Informal document No. **GRSP-35-5**
(35th GRSP, 3-7 May 2004,
agenda item B.1.1.)

PROPOSAL FOR DRAFT CORRIGENDUM TO REGULATION No. 14
Transmitted by the Italian delegation

This document introduces a corrigendum to the figure 6: ISOFIX Top tether anchorage location, ISOFIX zone – side view for document TRANS/WP.29/931 adopted by the Administrative Committee (AC.1) following the recommendation of WP.29 at its one-hundred-and-thirtieth session.

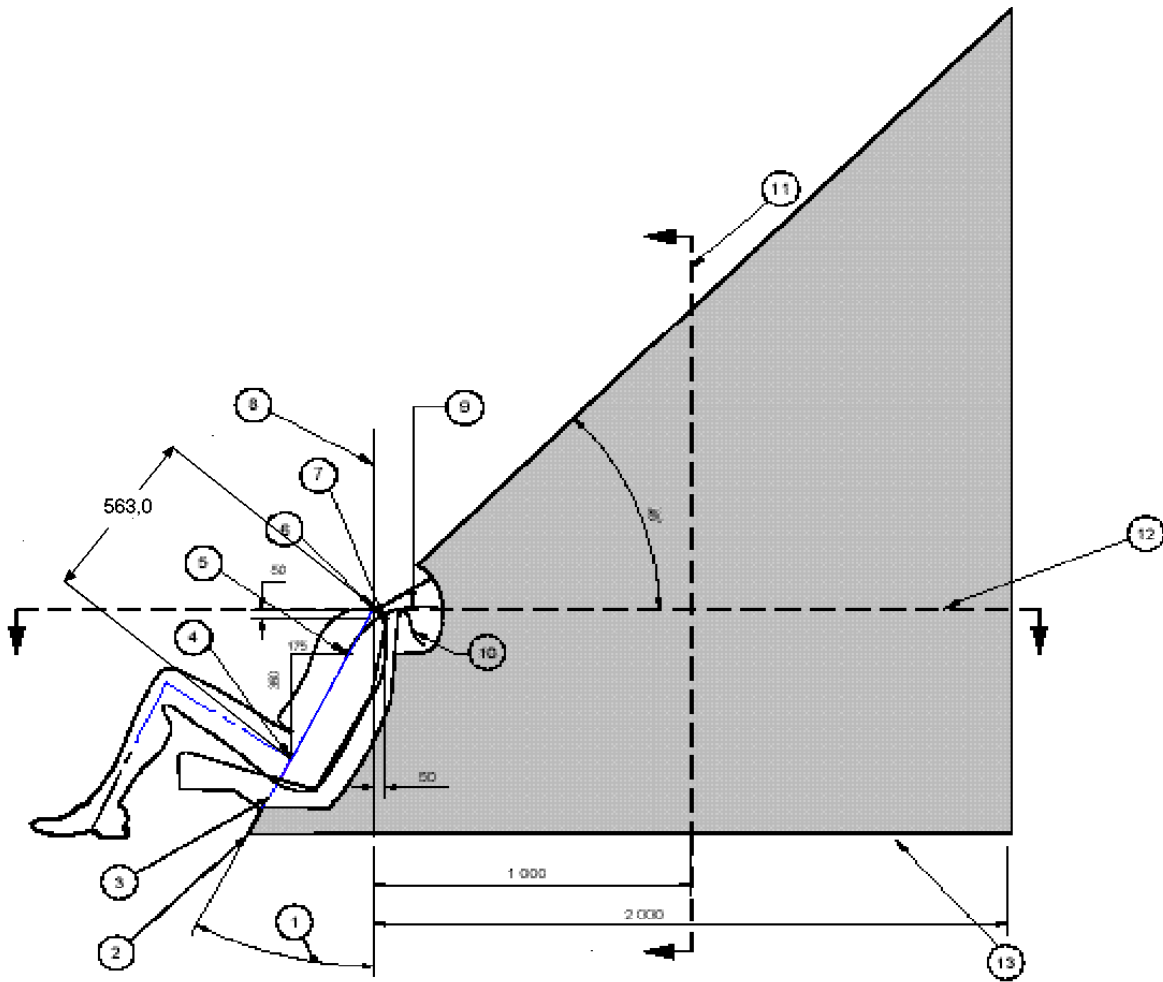
Insert a new dimensioning of 563.0 mm in figure 6 between R point and H point:

The document TRANS/WP29/931 adopted by AC1, introducing the figure n°6 concerning top tether location, lacks of diagonal distance between point “R” and point “H” of 563.0 mm (as reported in US STD 225). This lack hinders the right location of points “R” and “W” and as a consequence how to draw the shaded area.
